Re: Stepstone Substation

The Connecticut Light and Power Company  
Docket No. Stepstone Substation

Data Request CEAB -01

Pre-Stepstone Circuit Map.vsd

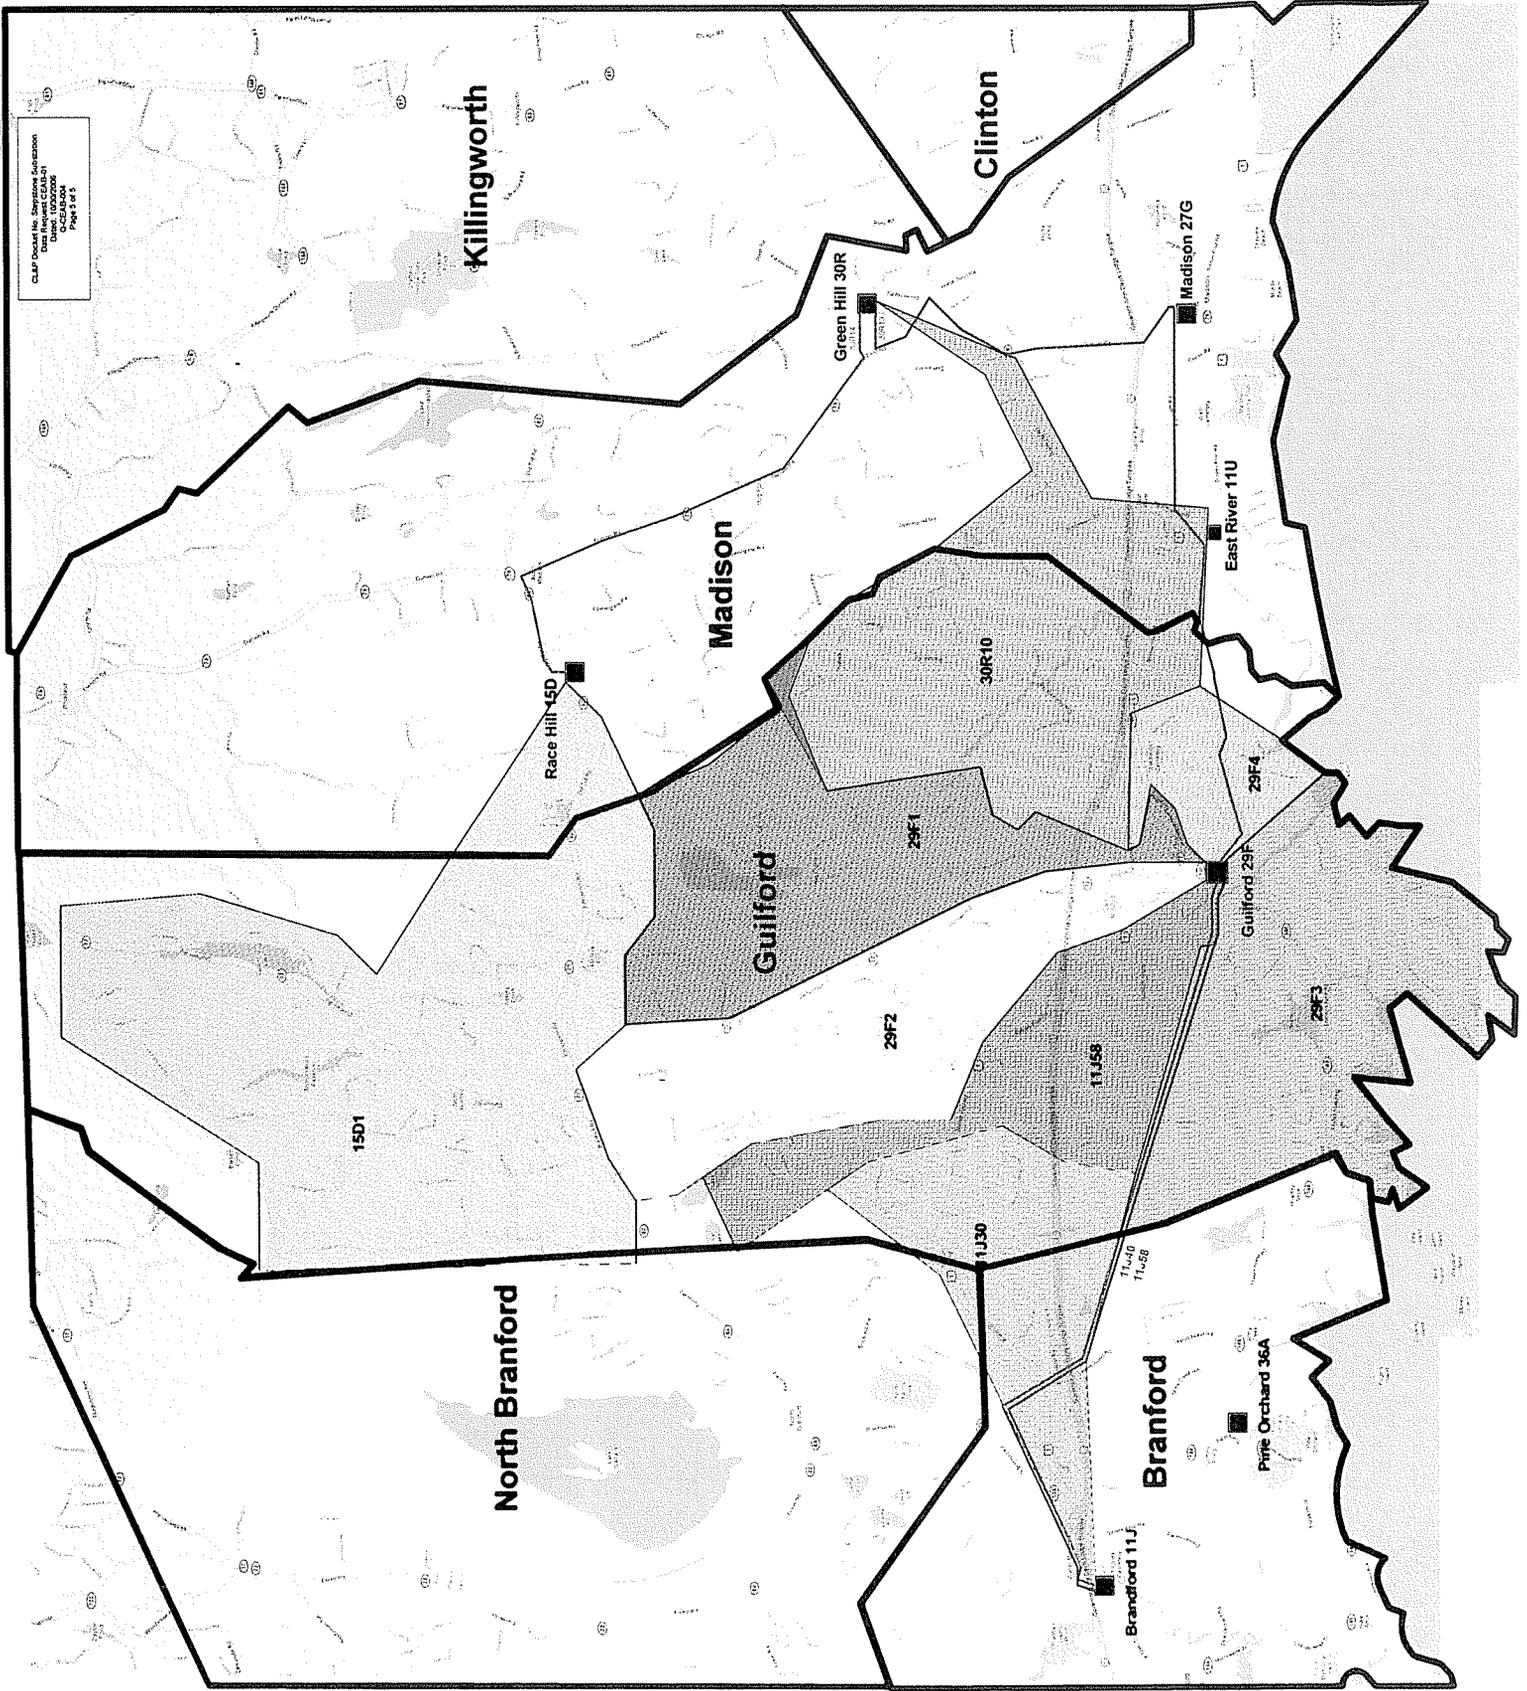
For each primary circuit currently being served by each of the substations listed in the table on page G -5 and other adjacent substations, please provide the most recent peak loads. Also provide a map showing the geographic area served by each primary circuit.

See the attached spreadsheet for the most recent peak loads on each primary circuit currently being served by each of the substations. See the attached Pre-Stepstone Circuit Map of the geographic areas served by each primary distribution circuit in the Town of Guilford.

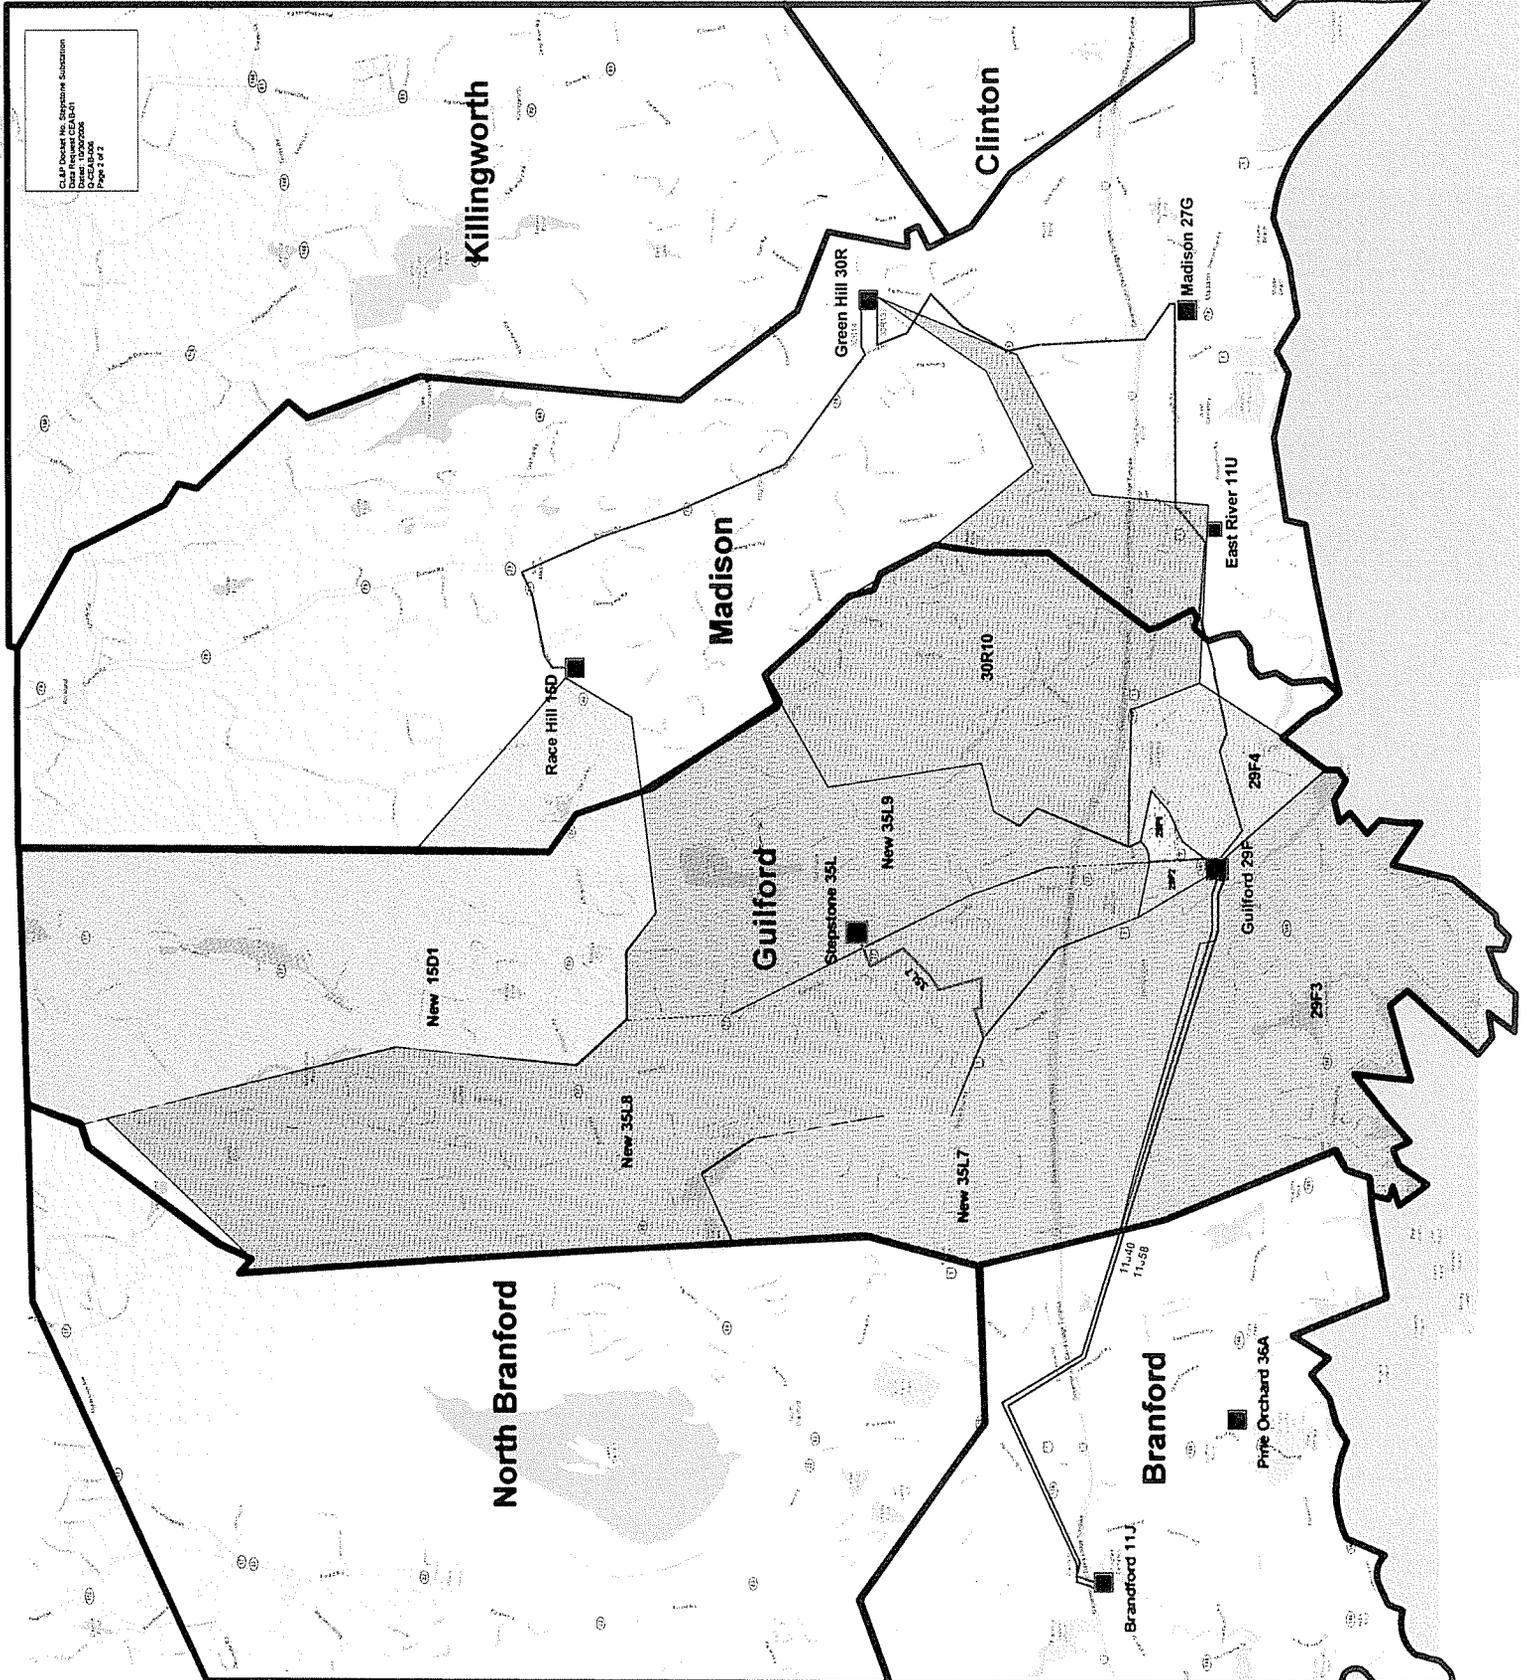
**Question:**  
For the proposed Stepstone Hill Substation, please provide a map showing the geographic area served by each circuit that will be supplied by this substation.

**Response:**  
Please see the attached Post-Stepstone Circuit Map.

# EXISTING CONNECTICUT TRANSMISSION SYSTEM

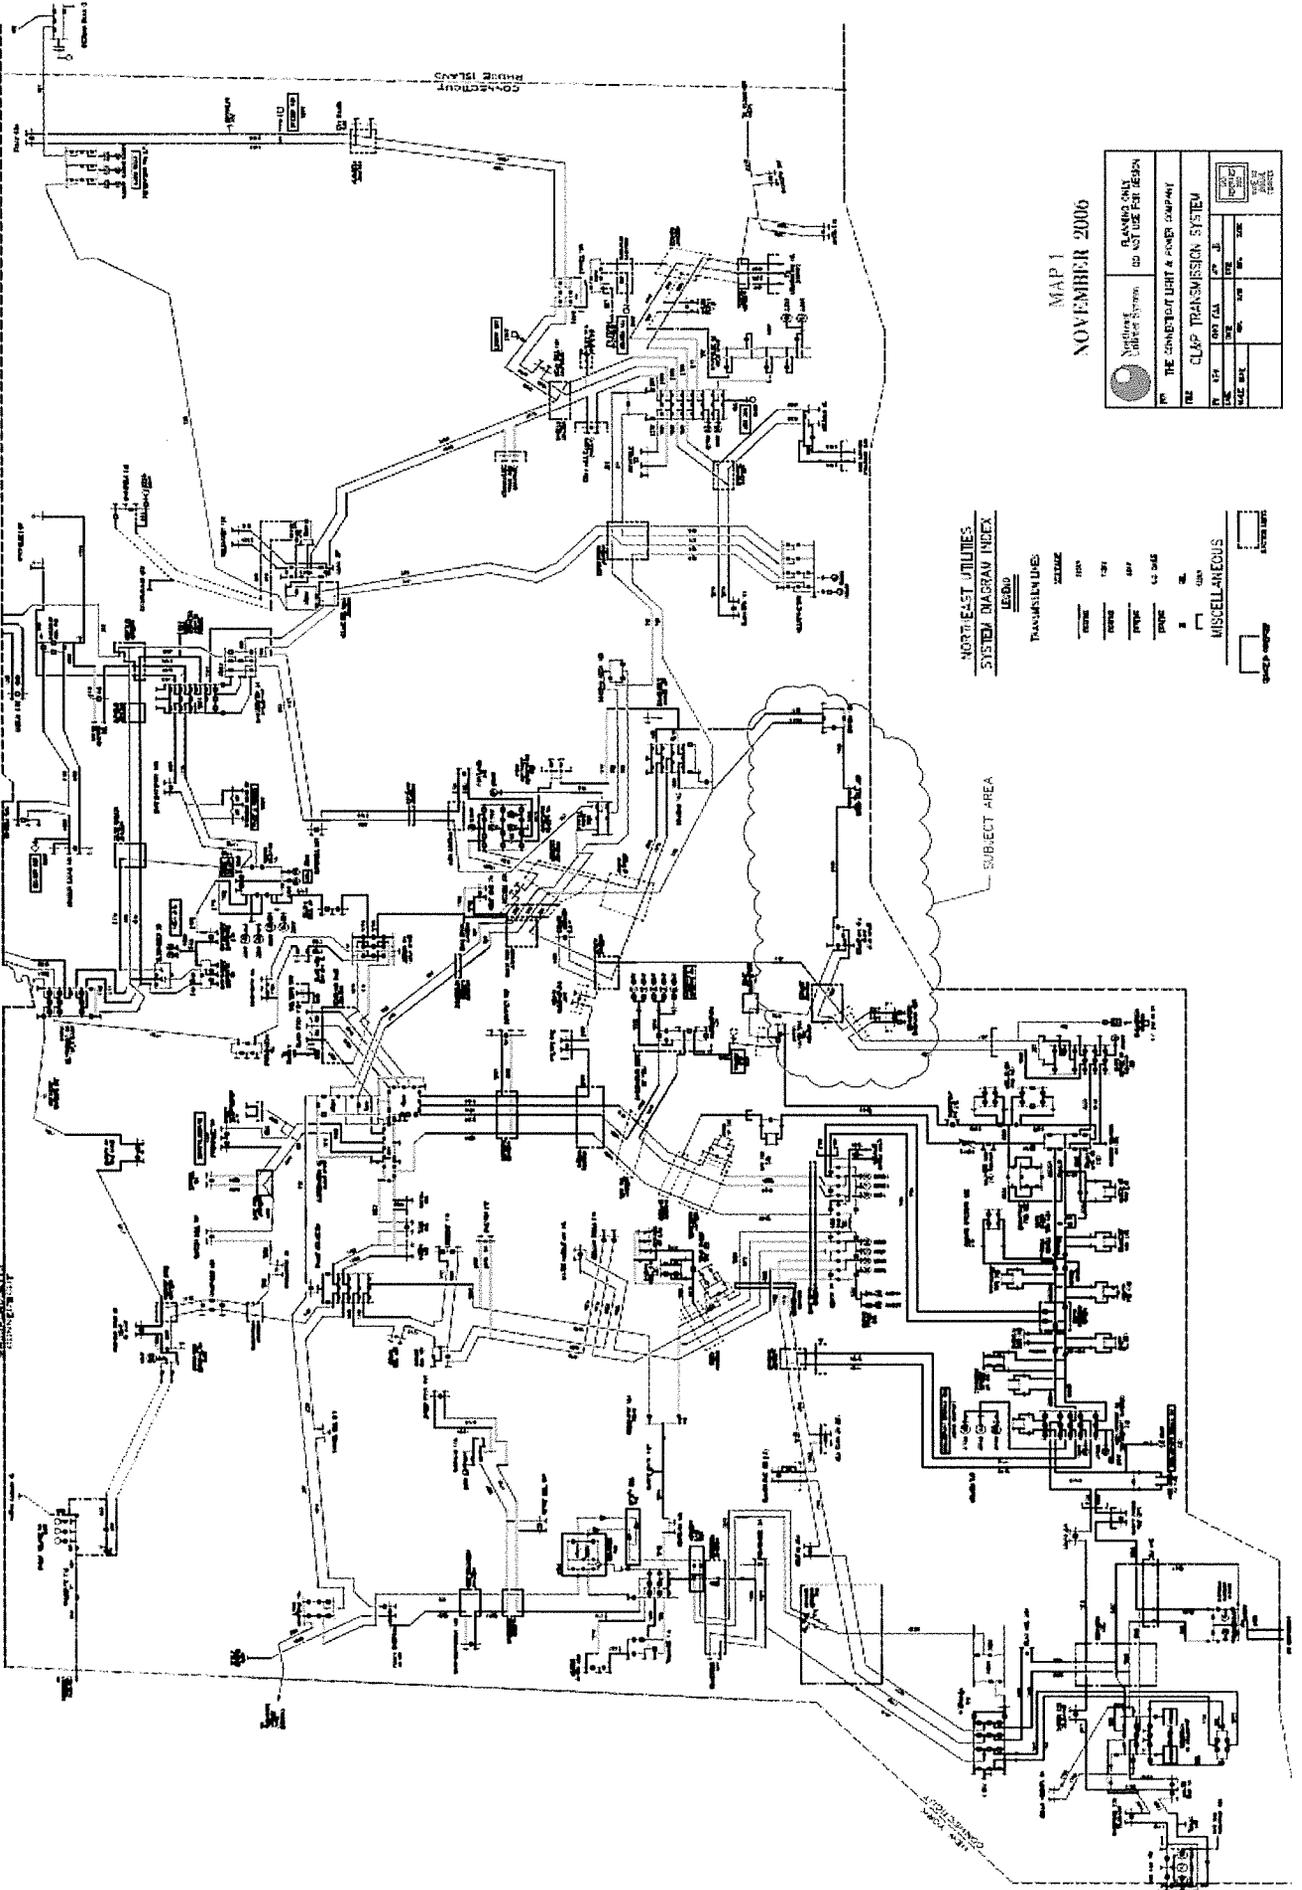
Please provide a map of the transmission system to which the Stepstone Hill Substations and all existing adjacent substations connect or will connect to.

Attached are two maps showing the transmission system to which the Branford, Green Hill, and Stepstone substations connect or will connect to.
